Consented VS Proposed

DESIGN SUMMARY

Stephenson's Way

Planning Permission Nr.: 2018/2316/P

Consented vs Proposed - Stephensons Way Street Elevation

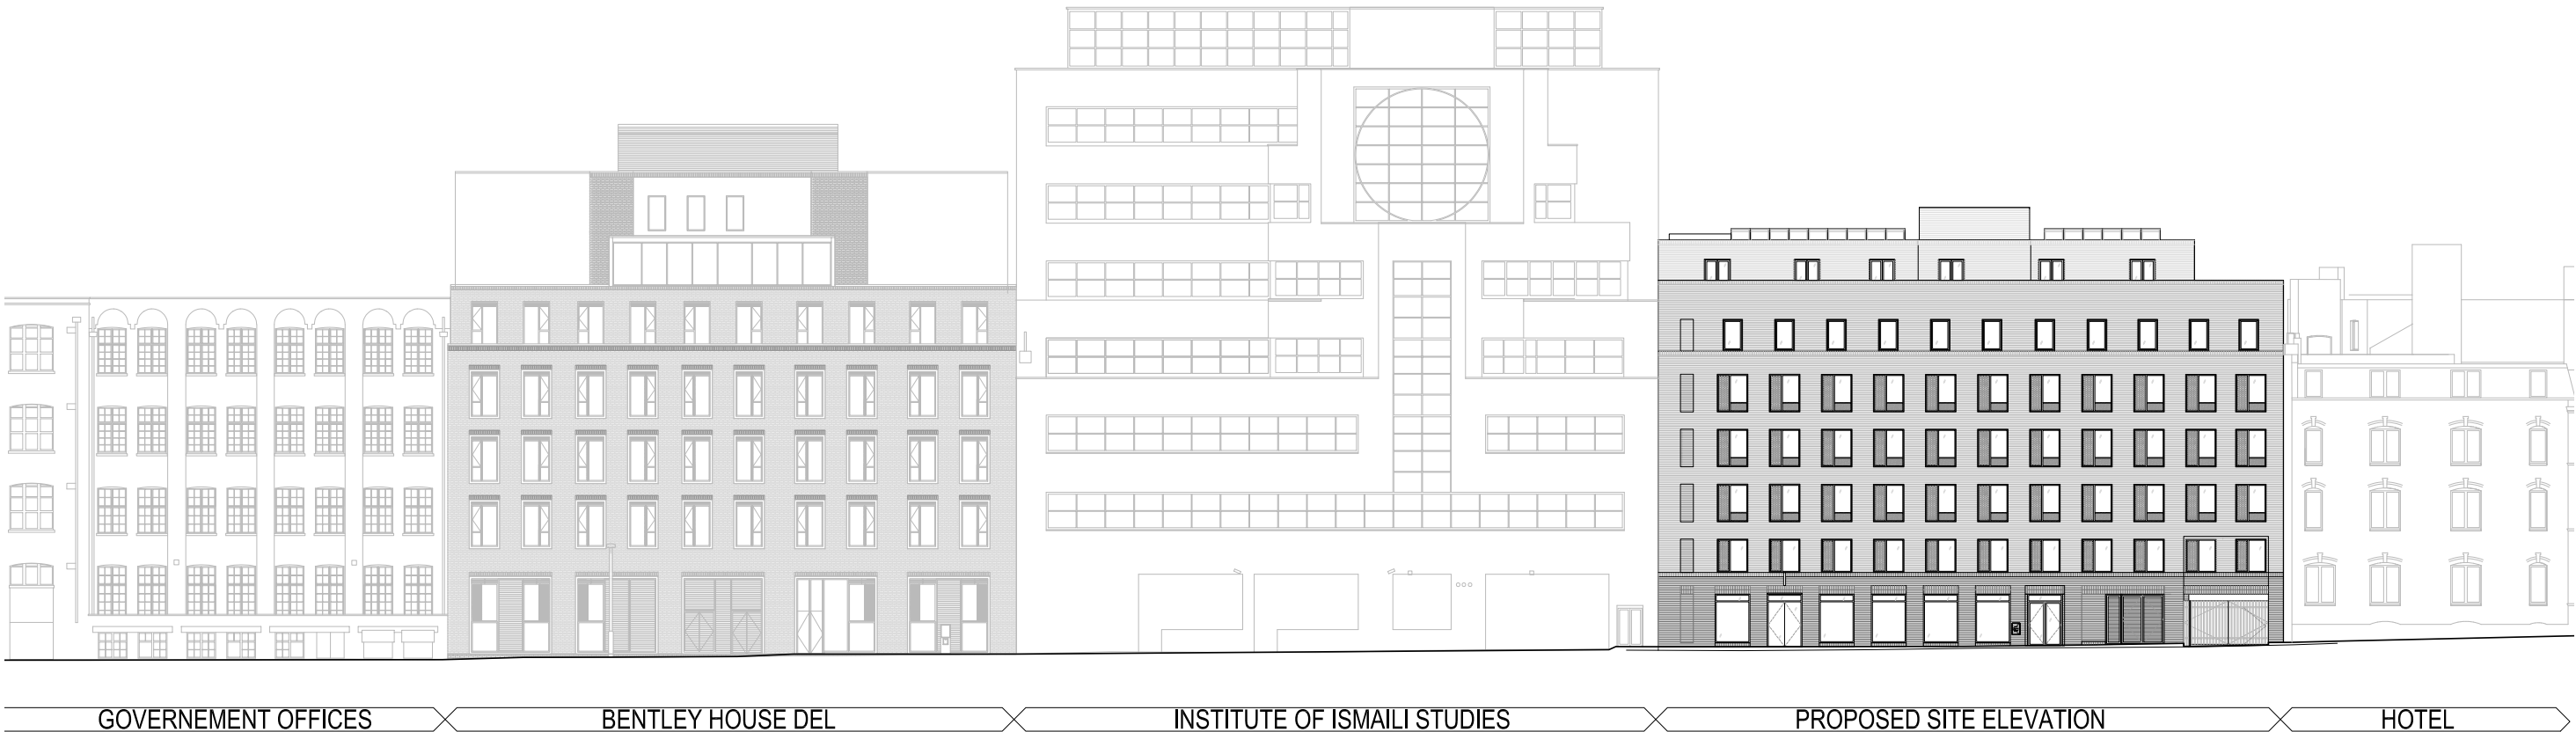
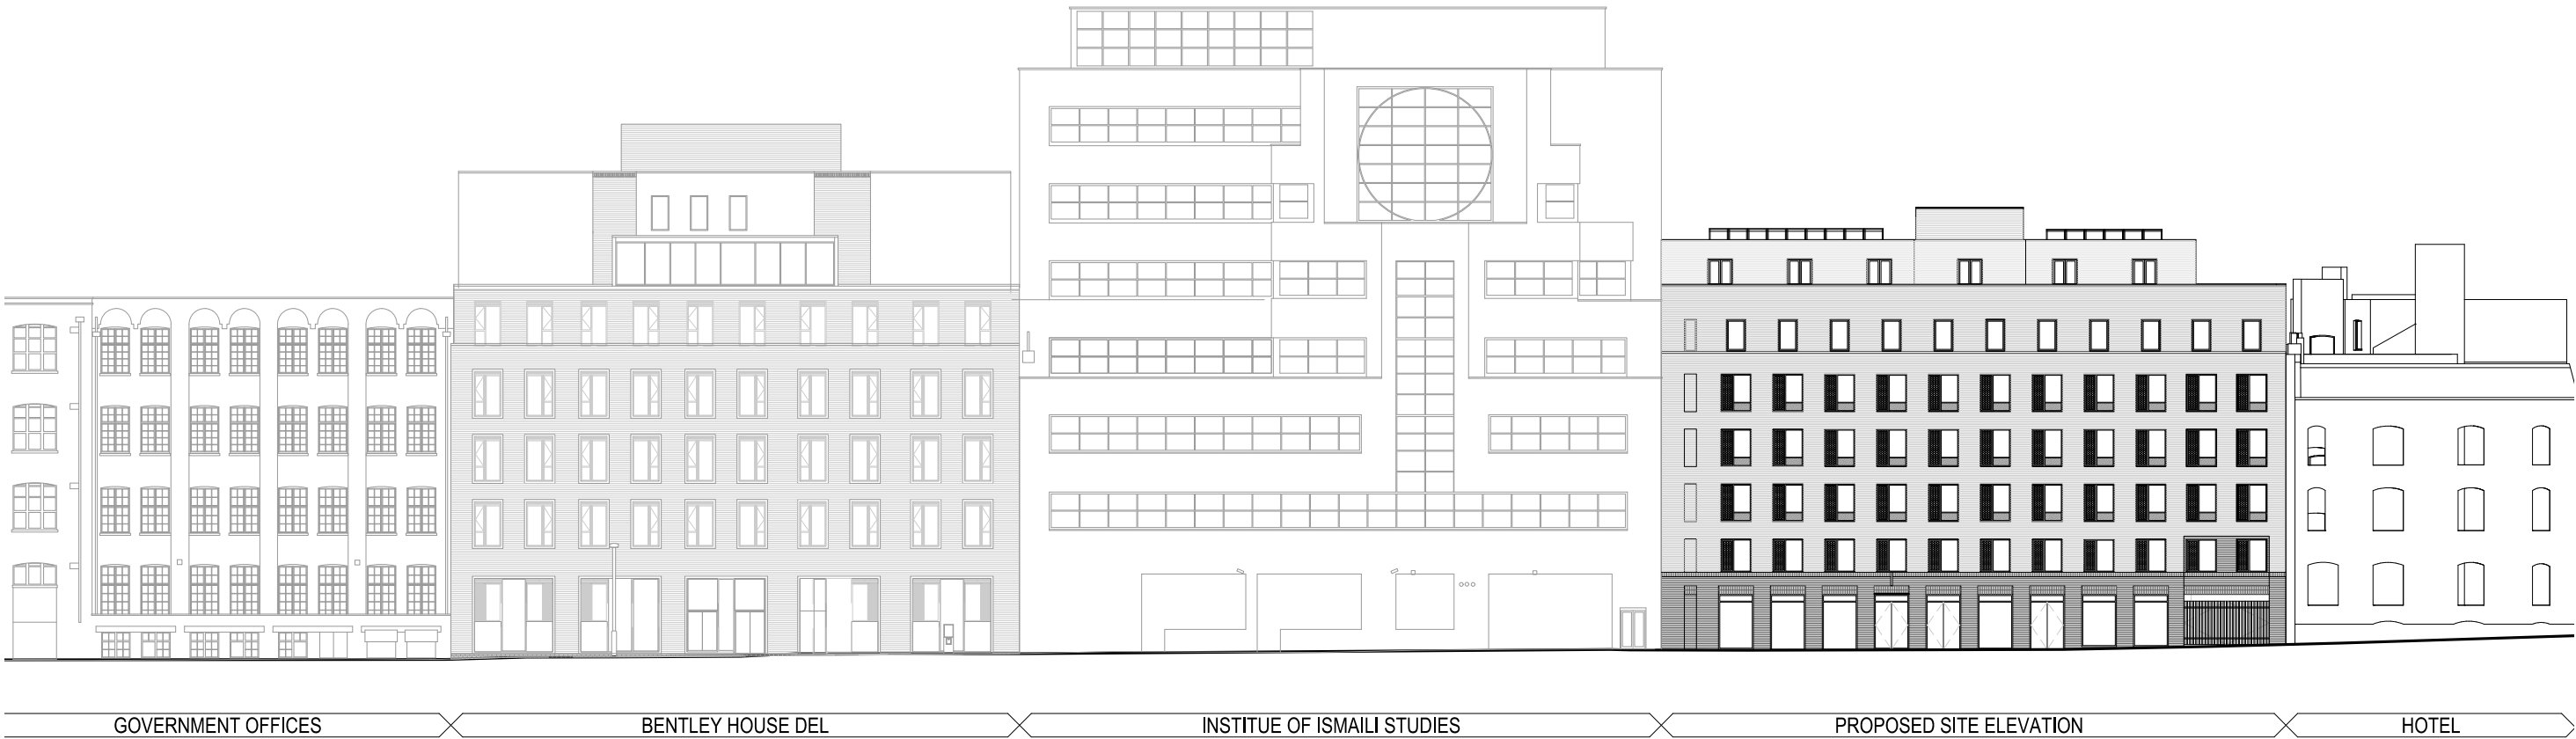
1. Secondary stair core added to comply with building safety act and revised building regulations.
2. Increased plant areas and UKPN substation added to comply with revised building regulations and increased services requirements.
3. Reduction in numbers of studios from 78 to 72 rooms due to secondary stair core and removal of threedio's on the recommendations of the fire consultant as a result of revised building regulations, but still maintaining minimum room sizes required.
4. Relocation of platform lift to rear façade to allow for access to the bin store due to new stair location.
5. Minor correction to existing ground floor levels due to inaccurate original survey.
6. Minor amendments to floor levels due to detailed structural design.

Consented vs Proposed - Ground Floor

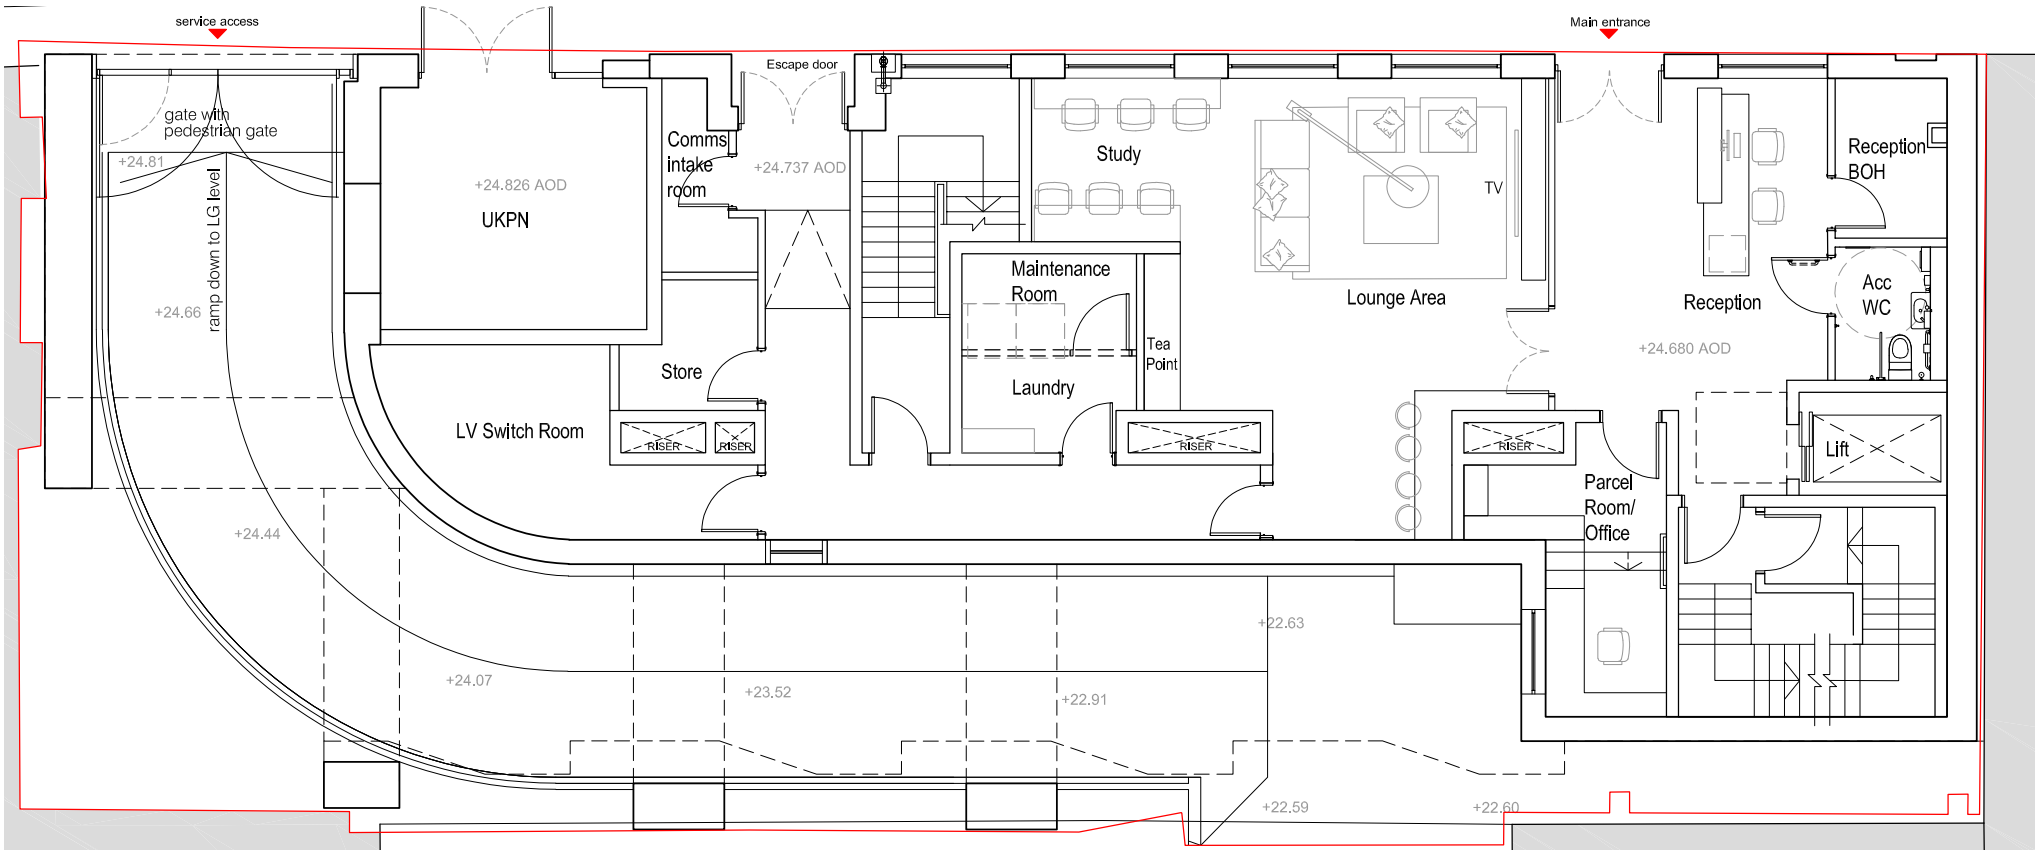
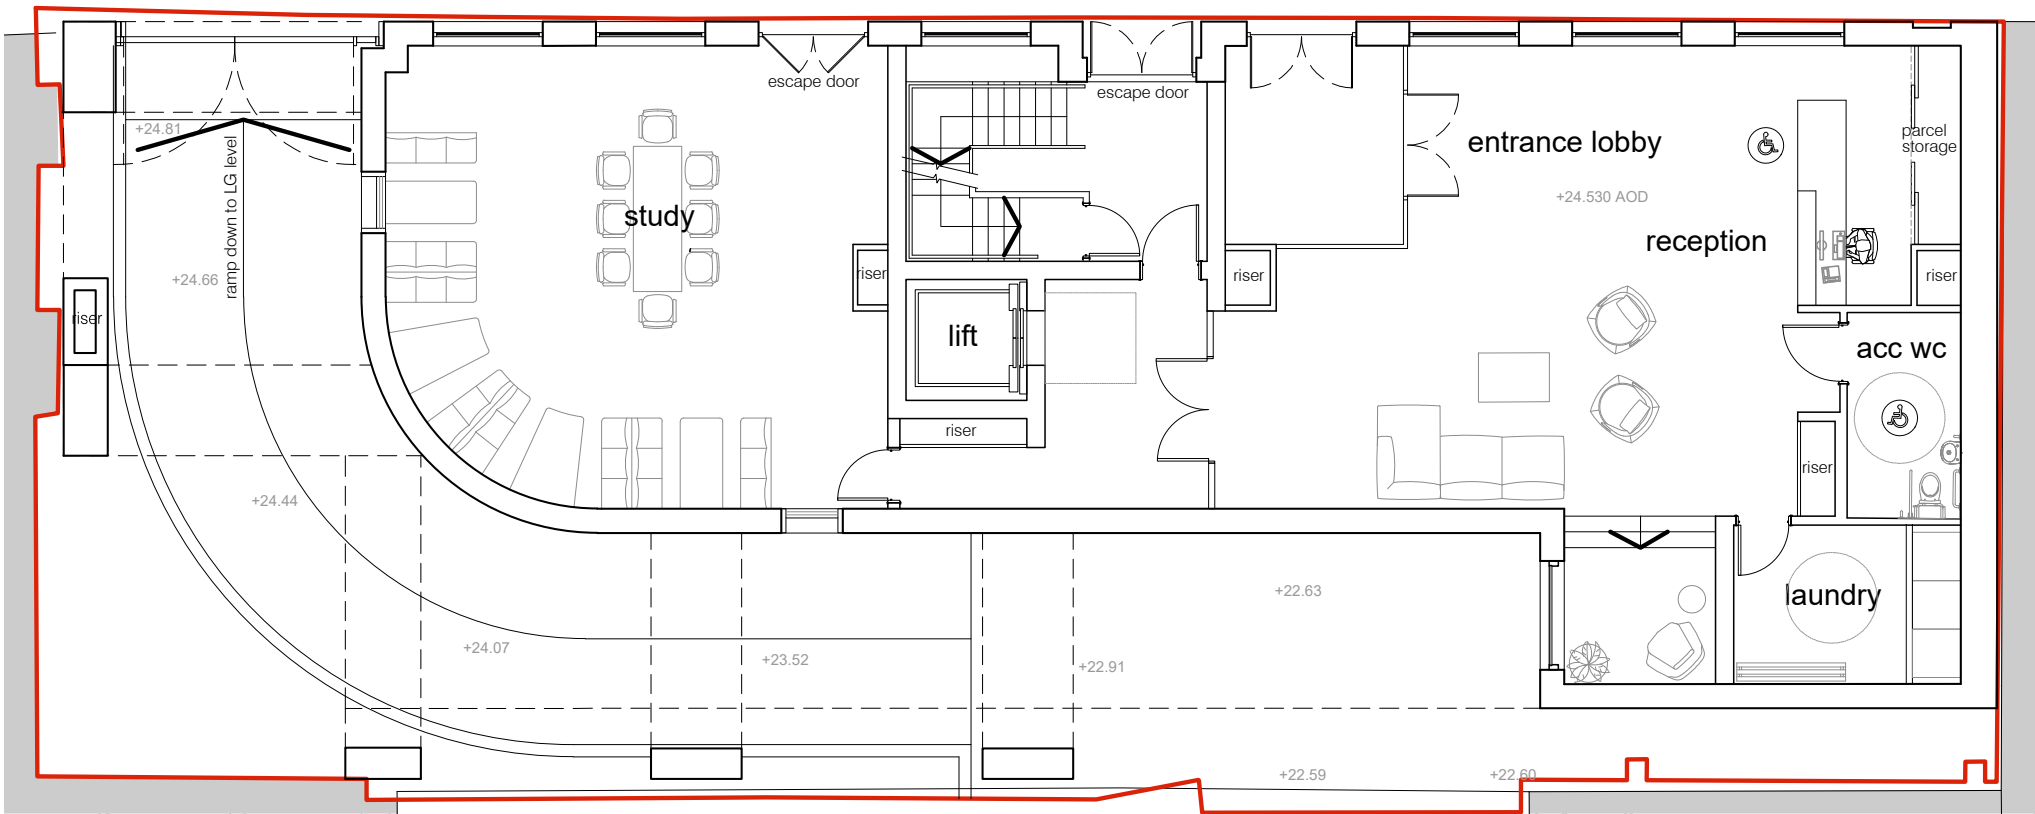
- 1. Secondary stair core added to comply with building safety act and revised building regulations.
- 2. Increased plant areas and UKPN substation added to comply with revised building regulations and increased services requirements.
- 3. Reduction in numbers of studios from 78 to 72 rooms due to secondary stair core and removal of threedio's on the recommendations of the fire consultant as a result of revised building regulations, but still maintaining minimum room sizes required.
- 4. Relocation of platform lift to rear façade to allow for access to the bin store due to new stair location.
- 5. Minor correction to existing ground floor levels due to inaccurate original survey.
- 6. Minor amendments to floor levels due to detailed structural design.

Consented vs Proposed - Basement Floor

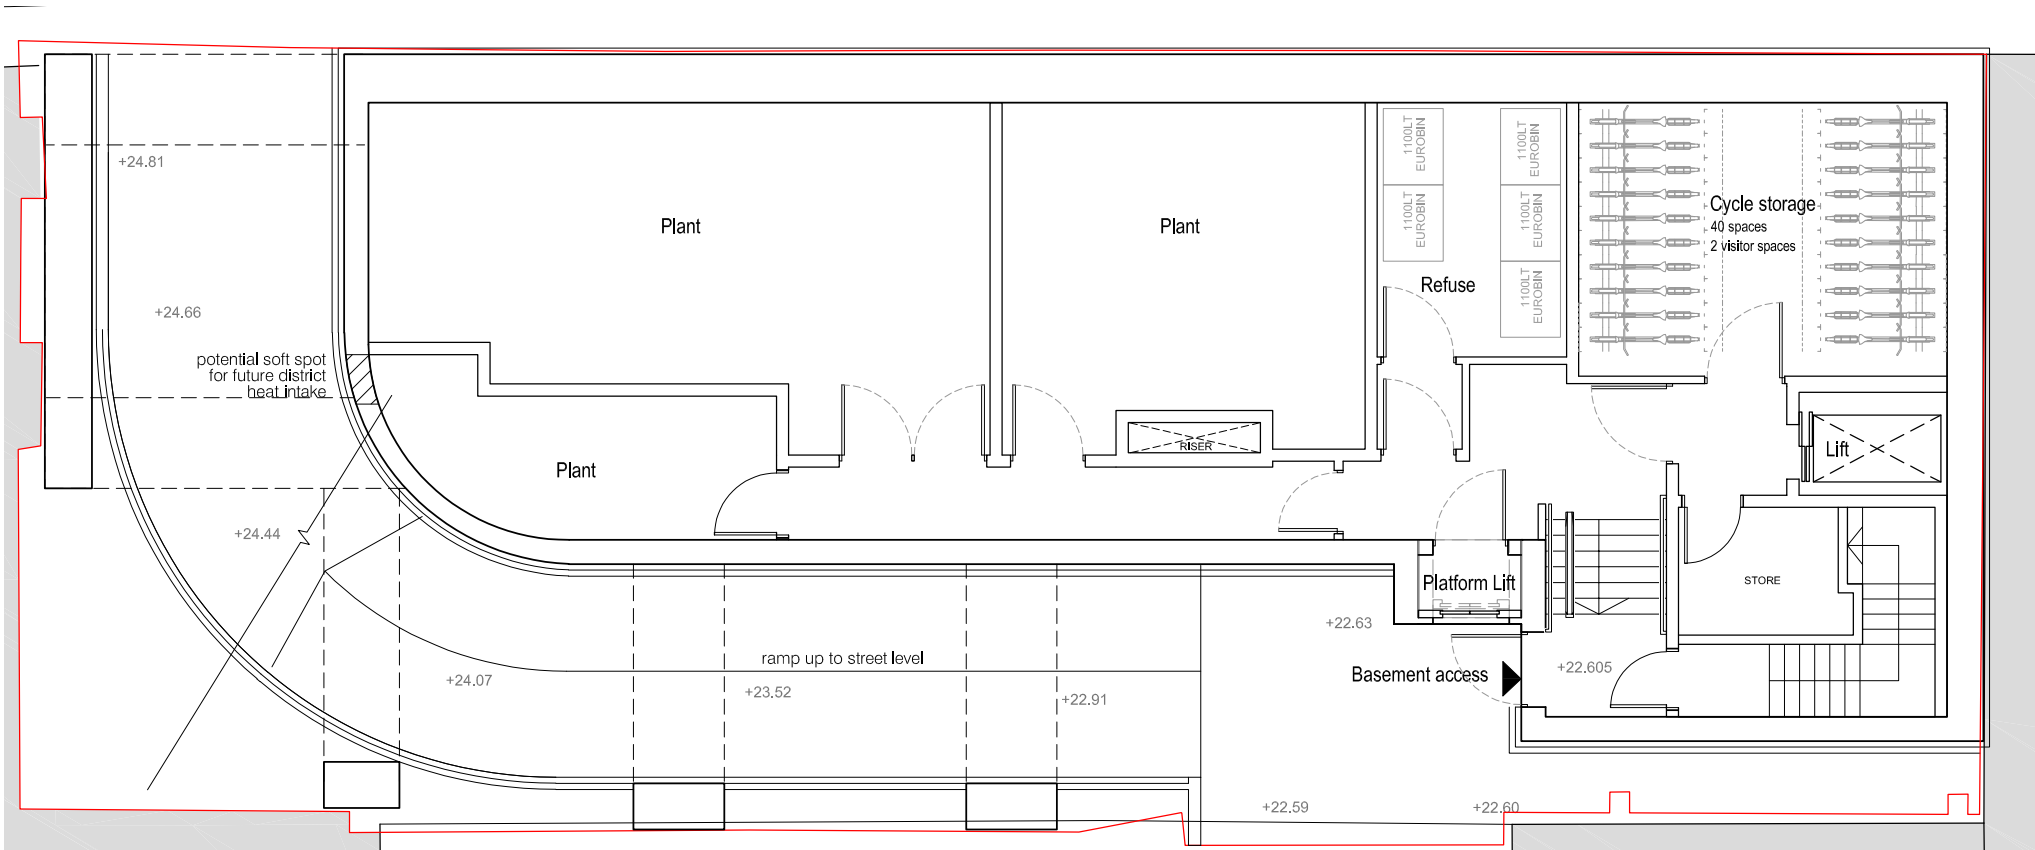
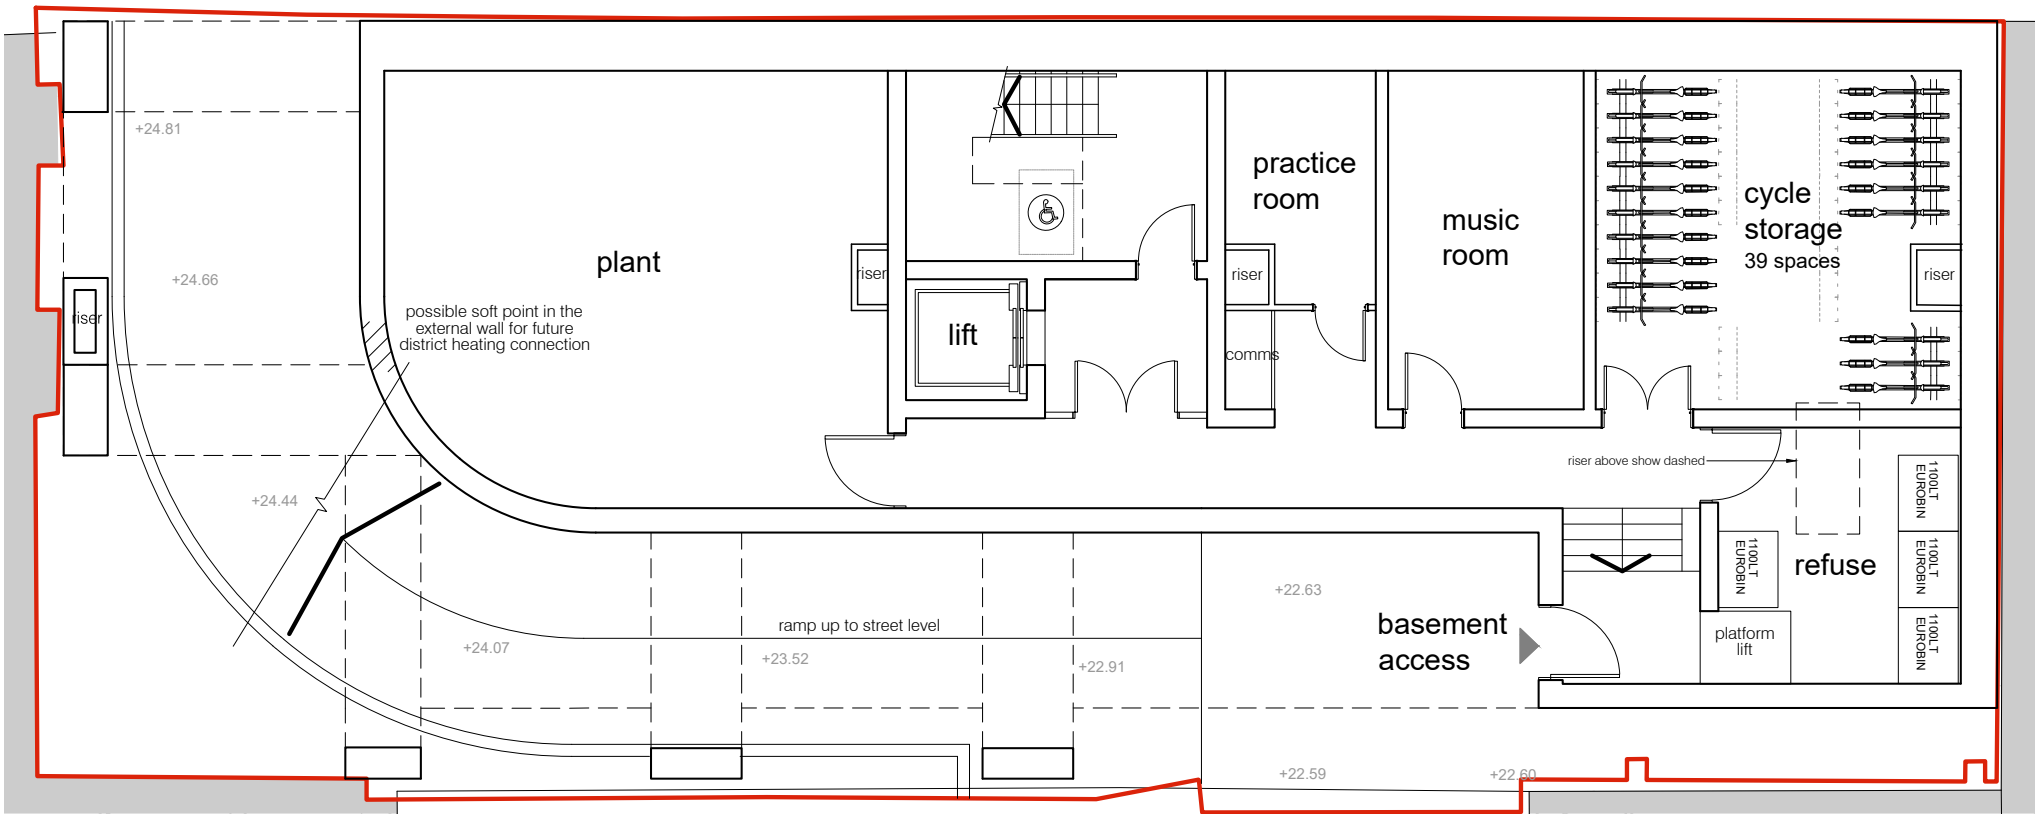
- 1. Secondary stair core added to comply with building safety act and revised building regulations.
- 2. Increased plant areas and UKPN substation added to comply with revised building regulations and increased services requirements.
- 3. Reduction in numbers of studios from 78 to 72 rooms due to secondary stair core and removal of threedio's on the recommendations of the fire consultant as a result of revised building regulations, but still maintaining minimum room sizes required.
- 4. Relocation of platform lift to rear façade to allow for access to the bin store due to new stair location.
- 5. Minor correction to existing ground floor levels due to inaccurate original survey.
- 6. Minor amendments to floor levels due to detailed structural design.
